Determination 2018/064

Regarding whether the fire safety design of a proposed 185m high mixed-use tower building at 71-77 and 87 Customs Street East, Auckland complies with Clauses C1-C6 by means of C/VM2

Figure 1: Plan L46 – showing ‘half floor’ apartments with connecting lobby between the lifts and West stair (not to scale)

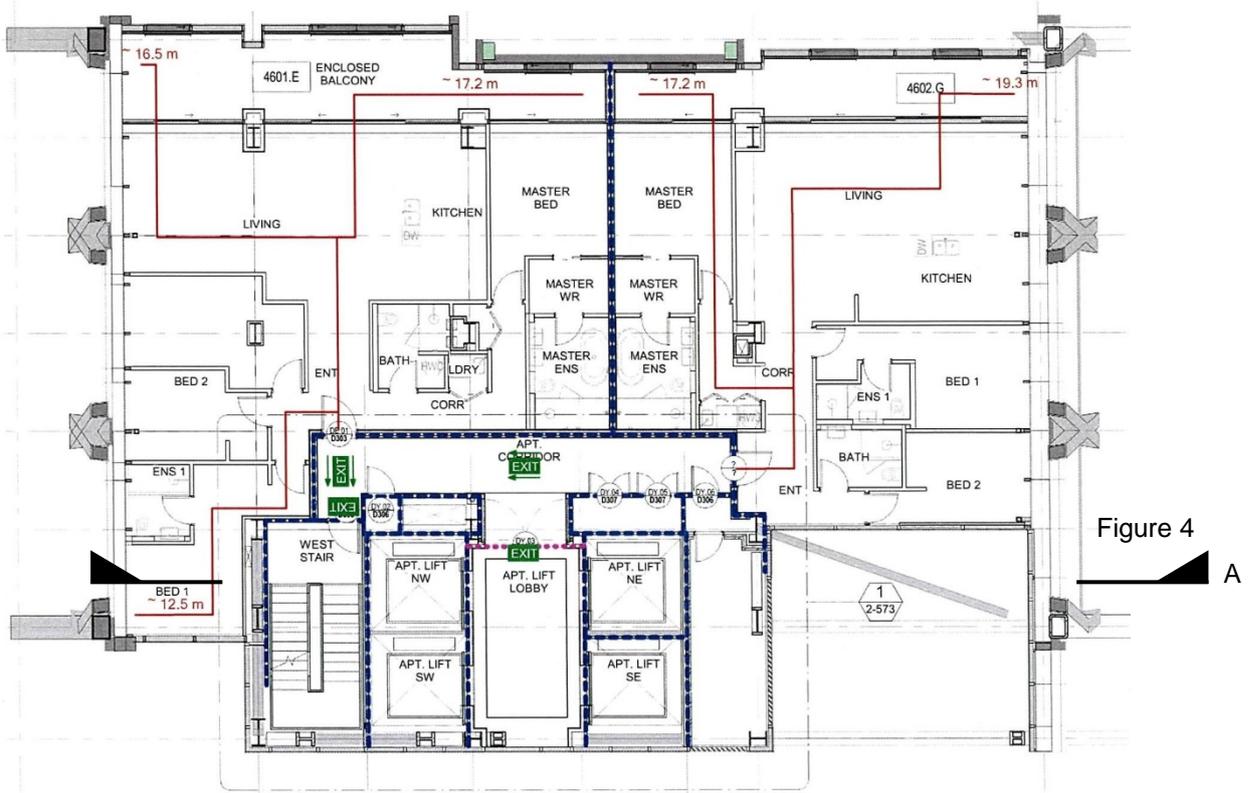
- Concerns raised by FENZ of large horizontal travel distances are overstated because the floor plate is smaller as the building tapers sharply.
- FENZ Standard Operating Procedure is to ascend two levels – in this case Level 46 +2, and therefore this issue only concerns three occupied levels and two plant rooms. Fire separated lift lobbies are detailed on all floors from Levels 47-51 and firefighters can don breathing apparatus equipment at any level and traverse the 6m from lift lobby to the upper west stair through apartments above Level 46.
- Titles can be encumbered on Levels 49-51 to keep a direct passage from the lift lobby to the stair ‘unaltered’.

Figure 2: Plan L47 – showing ‘full floor’ apartment with no connecting lobby between the lifts and West stair (not to scale)

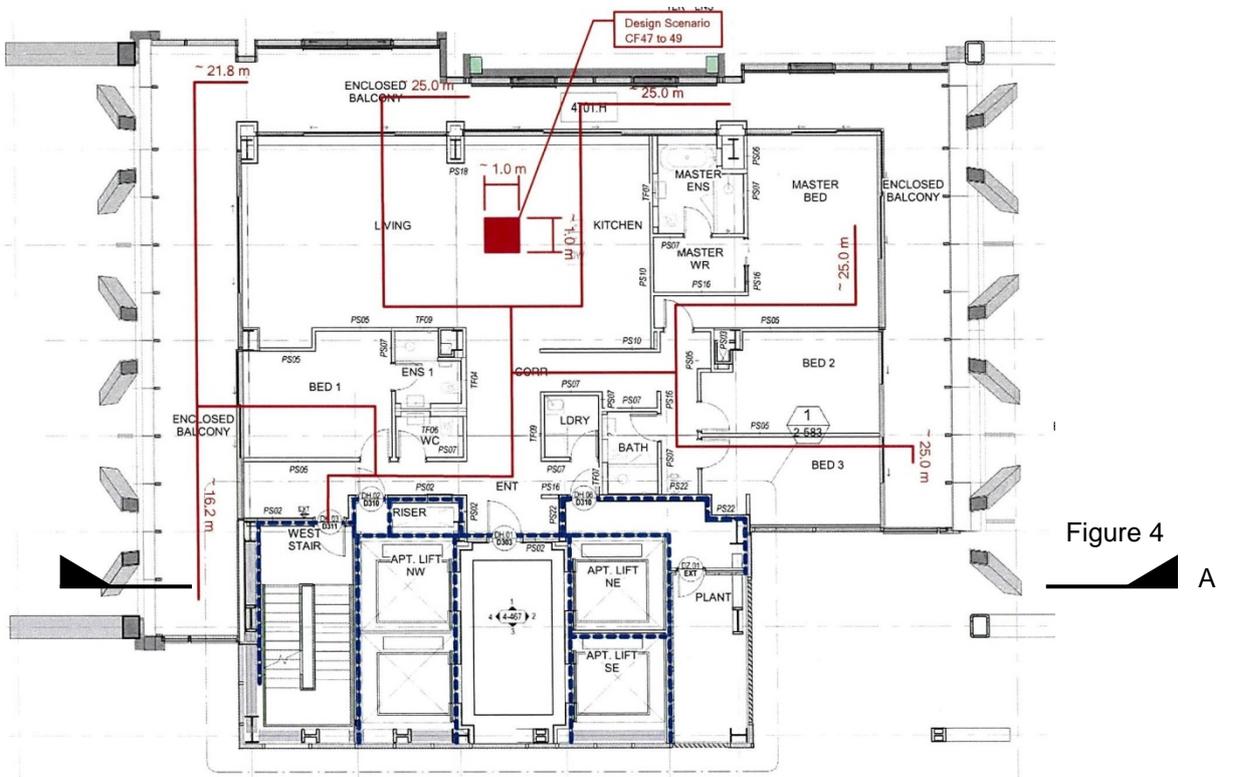
- 1.3.5 In correspondence subsequent to the application for determination (see Appendix C.1) the fire engineer identified a particular matter of compliance that remained in dispute, being ‘the absence of a direct or fire-isolated interconnection between the apartment lift lobby and the upper west stair servicing levels 41 to 55’ (refer Figures 1 to 4). FENZ expressed its concern regarding compliance with Clause C5.6⁸ as ‘the failure to provide lobbies as appropriate staging areas, or direct access between stairs and lifts ... above level 46’.

The availability of this route is not guaranteed because the internal layouts of the apartments may change. ... Without a connecting lobby, fire fighters who are expected to set up their staging area one or two floors below the fire floor (as per their standard training for high-rise building) may have difficulties in reaching the stair from the lift lobby to continue their firefighting activities.

FENZ	
18 October 2017	Reserving comment until the expert’s report and 2 nd draft are available.
25 October 2017	Guidance material can be used to help interpret the limits on application of Verification Methods, as part of their interpretation. FENZ does not accept the conclusion that the building is not outside the scope of C/VM2.
The authority	
30 October 2017	The comment to the scope of C/VM2 allows for displacement, and it is reasonable to do so in this instance. This is supported by Amendment 5 which confirms it was unsuitable for tall buildings. To uphold the principles in section 3, prior to the issue of the Amendment 5 the fire design should be assessed from first principles.
14 November 2017	The authority does not consider C/VM2 to be satisfied on the information supplied by the applicant.
24 November 2017	The matters in the RFI of 21 April 2017 remain outstanding, meaning the application for building consent is incomplete. The authority does not agree that the only matter to be resolved is compliance with Clause C5.6 with regard to the lack of smoke lobbies on Level 47 and above.
